UNITED STATES
NUCLEAR REGULATORY COMMISSION
WASHINGTON, D. C. 20555

The Commission has issued the enclosed Amendments Nos. 5 and 9 to Facility Operating Licenses Nos. DPR-24 and DPR-27 for the Point Beach Nuclear Plant, Units Nos. 1 and 2. The amendments include Changes Nos. 10 and 15 to the Technical Specifications and are in accordance with your application dated July 11, 1975.

This amendment will modify the reactor coolant system pressure temperature limits to account for neutron irradiation induced increases in reactor vessel metal nil ductility temperature (RT_{NDT}).

SUPPORTING AMENDMENT NOS. 5 AND 9 TO LICENSE NOS. DPR-24 AND DPR-27

FIGURE I5.3.1-1

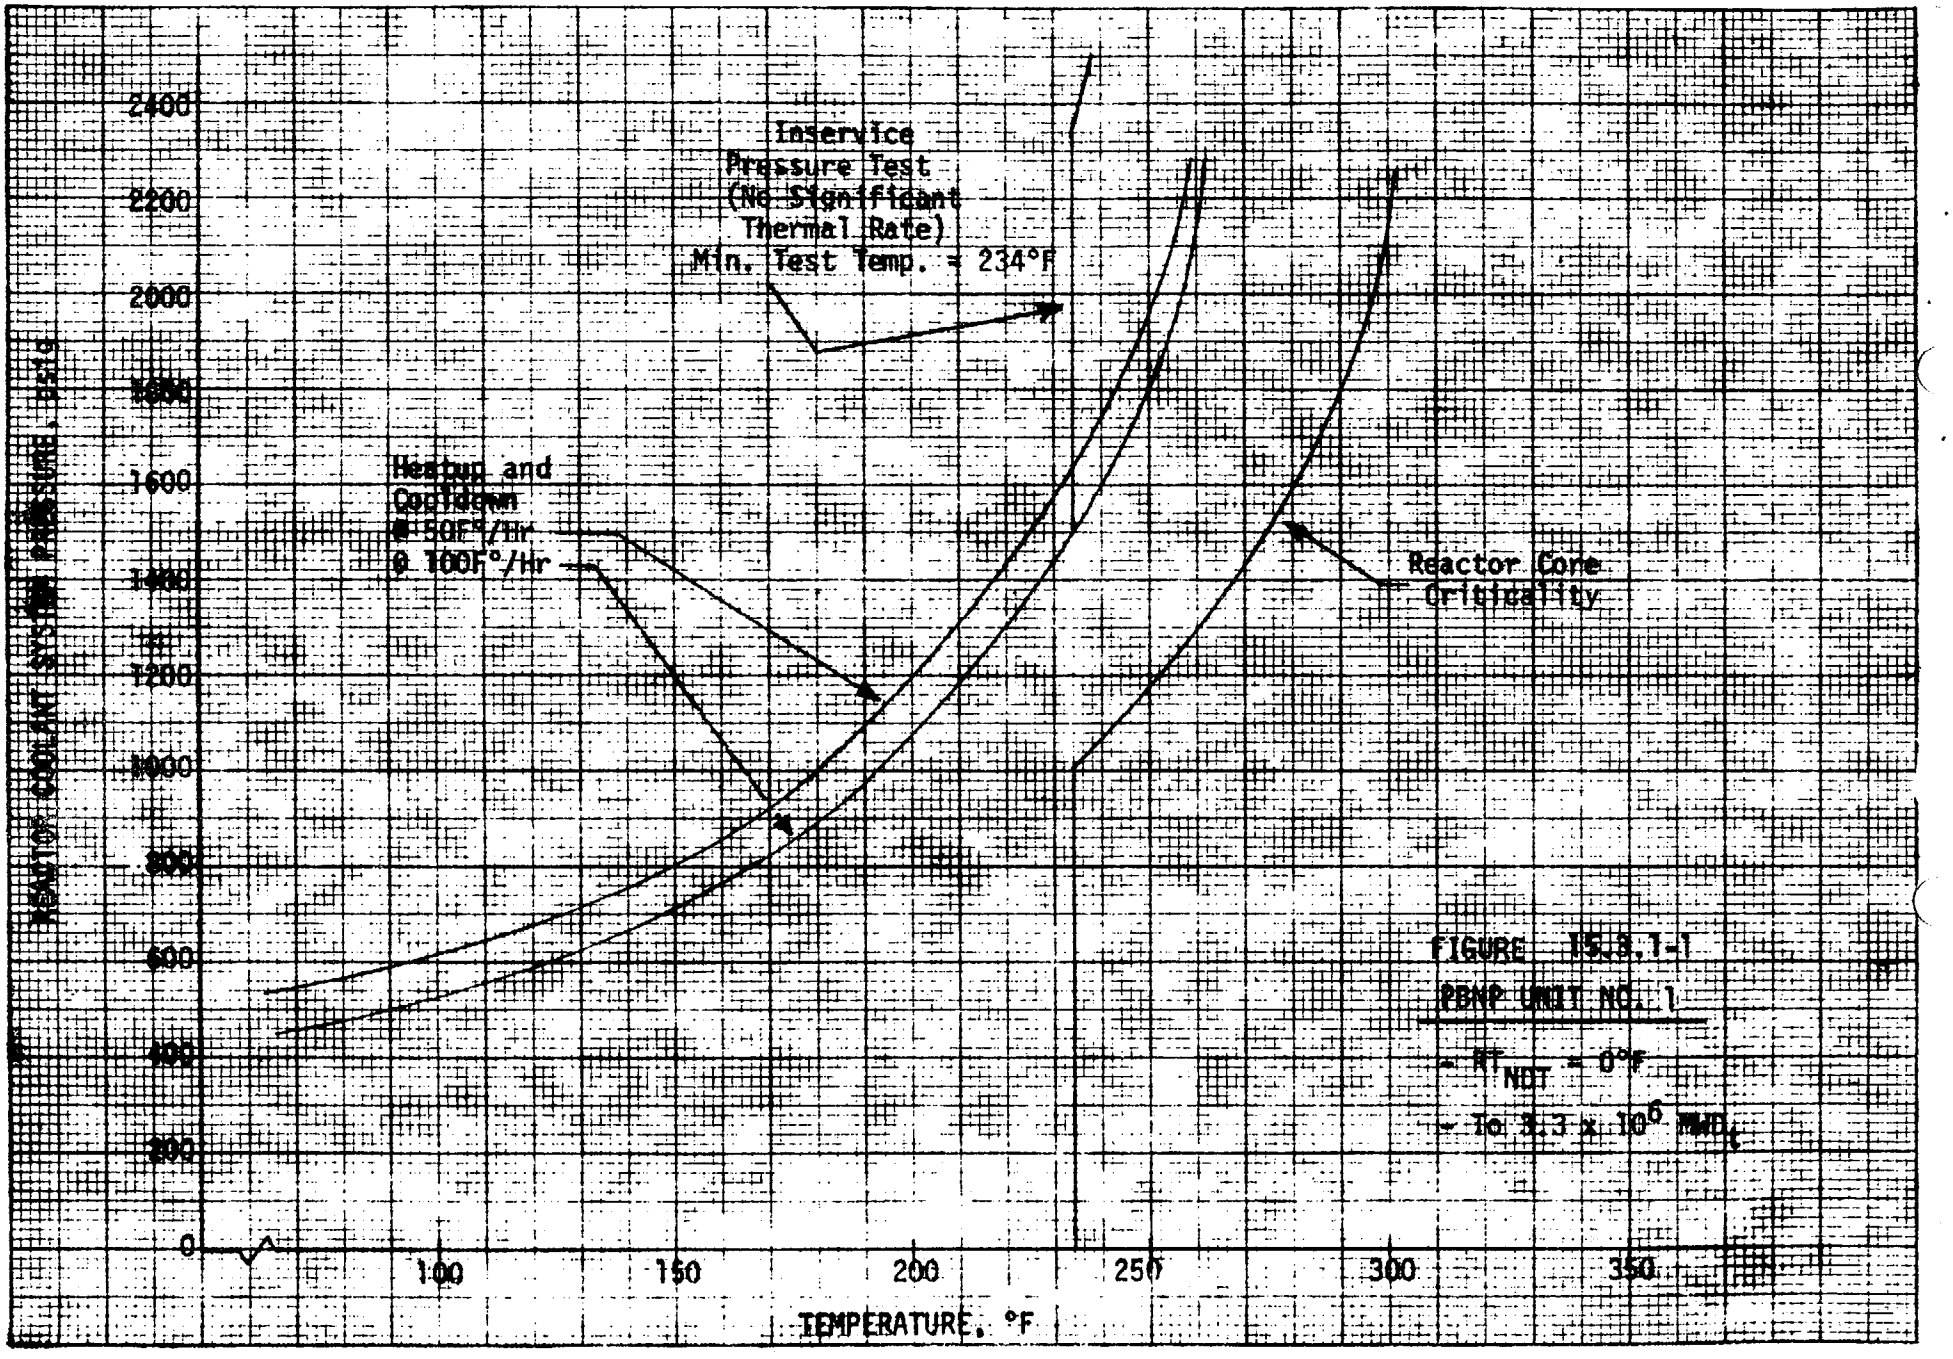
Replace pages 15.3.1-3, 15.3.1-4 through 15.3.1-8 and 15.3.1-17 and 15.3.1-18, and Figure 15.3.1-1 with the attached revised pages. (No change made on page 15.3.1-3.)

1. The Reactor Coolant System temperature and pressure shall be limited in accordance with the limit lines shown in Figure 15.3.1-1 (Unit 1) during heatup, cooldown, criticality, and inservice leak and hydrostatic testing with: 10

2. In no case shall the reactor be made critical (other than for the purpose of low level physics tests) to the left of the Reactor Core Criticality curve presented in figures 15.3.1-1 for Unit 1. 10

The pressure-temperature limits defined for hydrostatic leak tests (Figure 15.3.1-1 for Unit 1 and Figure 15.3.1-2 for Unit 2) were determined in a similar manner as the limits discussed above and in accordance with the ASME Code. In this case, however, there was no need for consideration of the thermal gradient stress intensity factor because no significant metal heatup or cooldown occurs during the hydrostatic test. We have reviewed the proposed limits and conclude that they meet the requirements of Appendix G to 10 CFR Part 50; and therefore are acceptable.

The proposed limits (Figure 15.3.1-1 for Unit 1 and Figure 15.3.1-2 for Unit 2) were derived using methods described earlier with additional safety factors required by Appendix G to 10 CFR Part 50. These additional factors include the temperature for criticality (equal to that of hydrostatic test) and an additional 40°F temperature increase beyond the operating pressure-temperature limits discussed earlier. We have reviewed the basic test data, the analytical techniques and the resultant limits and conclude that they meet the requirements of Appendix G to 10 CFR Part 50; and therefore are acceptable.

In developing these curves, an initial unirradiated RT_{NDT} of 0°F for Unit 1 was used. As a result of fast neutron irradiation, there will be an increase in the RT_{NDT} with nuclear operation. The maximum integrated fast neutron exposure of the vessel is computed to be 3.8×10^{19} neutrons/cm^2 for 40 years of operation at 1520 Mwt and 80 percent load factor.(2). This is the exposure expected at the inner reactor vessel wall. However, the neutron fluence used to predict RT_{NDT} shift is the one quarter shell thickness neutron exposure. This is assumed to be 2/3 of the fluence seen at the inner vessel wall. The RT_{NDT} shift due to irradiation is predicted from the "max" for 550°F curve in FFDSAR Figure 4.2-7 for Unit 1.

The heatup and cooldown curves presented in Figure 15.3.1-1 (Unit 1) were calculated based on the above information and the methods of ASME Code Section III (1974 Edition) Appendix G, "Protection Against Nonductile Failure" and are applicable up to the operation exposure indicated on the figures.

FIGURE 15.3.1-2
PBNP UNIT NO. 2

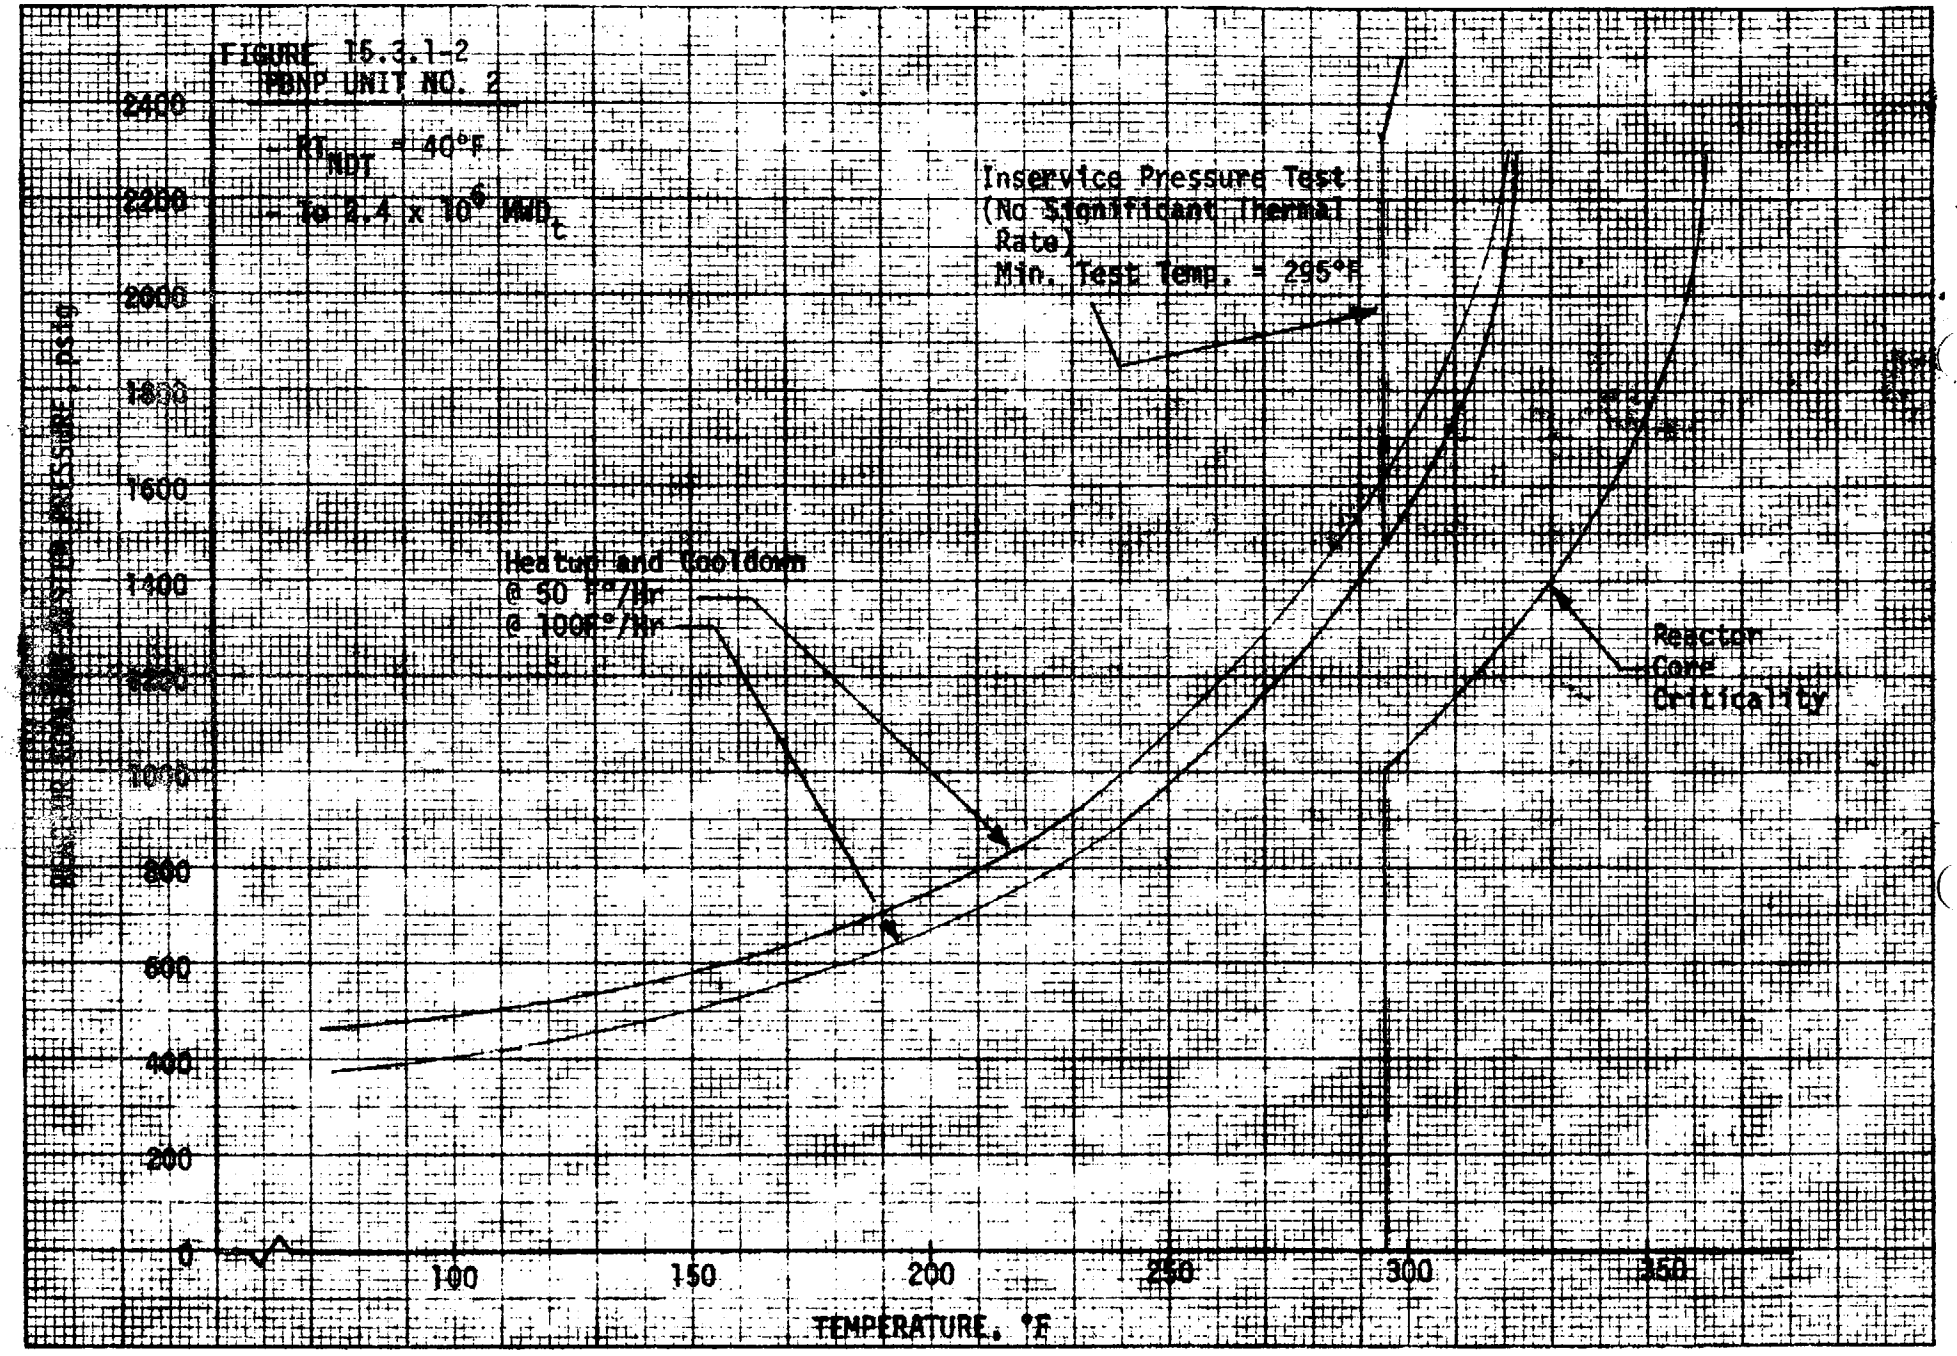
Replace pages 15.3.1-3, 15.3.1-4 through 15.3.1-8 and 15.3.1-17 and 15.3.1-18, and Figure 15.3.1-2 with the attached revised pages. (No change made on page 15.3.1-3.)

1. The Reactor Coolant System temperature and pressure shall be limited in accordance with the limit lines shown in 15.3.1-2 (Unit 2) during heatup, cooldown, criticality, and inservice leak and hydrostatic testing with:
   a. A maximum heatup of 100°F in any one hour,
   b. A maximum cooldown of 100°F in any one hour, and
   c. An average temperature change of ≤10°F per hour during inservice leak and hydrostatic testing operations.

2. In no case shall the reactor be made critical (other than for the purpose of low level physics tests) to the left of the Reactor Core Criticality curve presented in figure 15.3.1-2 for Unit 2. 15

In developing these curves, an initial unirradiated RT_{NDT} of 40° for Unit 2 was used. As a result of fast neutron irradiation, there will be an increase in the RT_{NDT} with nuclear operation. The maximum integrated fast neutron exposure of the vessel is computed to be 3.8×10^{19} neutrons/cm^2 for 40 years of operation at 1520 Mwt and 80 percent load factor.[2] This is the exposure expected at the inner reactor vessel wall. However, the neutron fluence used to predict RT_{NDT} shift is the one quarter shell thickness neutron exposure. This is assumed to be 2/3 of the fluence seen at the inner vessel wall. The RT_{NDT} shift due to irradiation is predicted from the "max" for 550°F curve in FFDSAR Figure 4.2-7A for Unit 2.

The heatup and cooldown curves presented in Figure 15.3.1-2 (Unit 2) were calculated based on the above information and the methods of ASME Code Section III (1974 Edition) Appendix G, "Protection Against Nonductile Failure" and are applicable up to the operation exposure indicated on the figures.
